Received by MCD: 3/3/2025 8:07:49 AM U.S. Department of the Interior BUREAU OF LAND MANAGEMENT		Sundry Print Report 03/03/2025
Well Name: SD WE 14 FEDERAL P 5	Well Location: T26S / R32E / SEC 14 / SWSW / 32.0356078 / -103.6521667	County or Parish/State: LEA / NM
Well Number: 1H	Type of Well: OIL WELL	Allottee or Tribe Name:
Lease Number: NMNM118722	Unit or CA Name:	Unit or CA Number:
US Well Number: 3002542800	Operator: CHEVRON USA INCORPORATED

Type of Submission: Notice of Intent

Type of Action: Temporary Abandonment Time Sundry Submitted: 10:00 0

Conditions of Approval for Temporary Abandonment of Wells

SD WE 14 Federal P5 1H PROPOSED WELLBORE

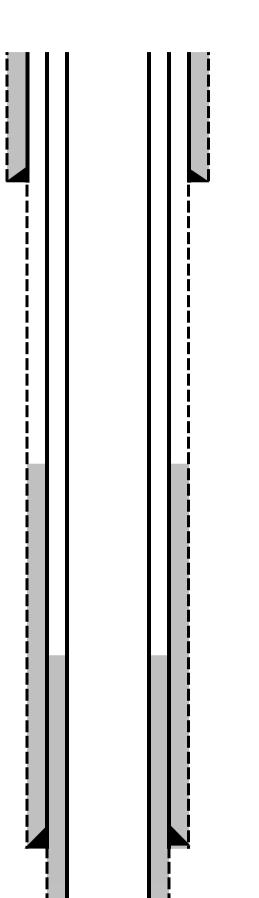
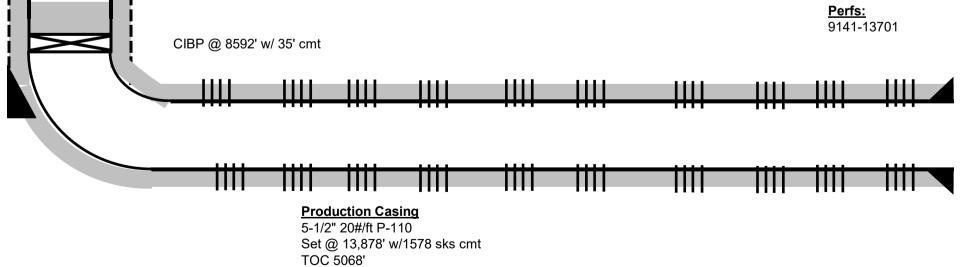
- 2. A bridge plug (CIBP) must be installed 50 to 100 feet above any open perforations/open hole/kick off point. The CIBP must be capped with either a minimum of 25 sacks of cement if placed with tubing or 35 feet of cement if placed with a bailer. The top of the cement must be verified by tagging.

- 3. The wellbore must be filled with corrosion inhibited fluid and pressure tested to 500 psi. The casing shall be capable of holding this pressure for at least 30 minutes. If the well does not pass the casing integrity test, then the operator shall, within 30 days, submit a procedure to either repair the casing or to plug and abandon the well.
